Modification Recommended Service Note

6651A DC power supply, 0-8 V, 0-50 A, 400 W. GPIB

Serial Numbers: "MY53000140 to MY53000698 and SG53000101 to SG53000108"

The Problem – 6651A exhibited out of specification values for 3.8V to 4.2V at front panel read back readings.

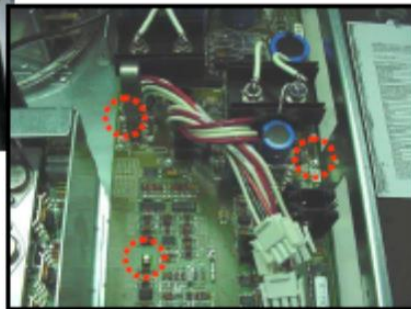
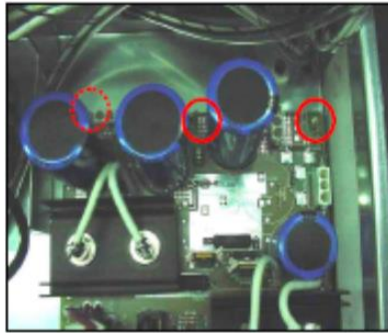
6651A exhibited out of specification values for 3.8V to 4.2V at front panel read back readings. Other ranges and remote programming's behaved normally.

10. Replace with a new PCA board (06651-61020)
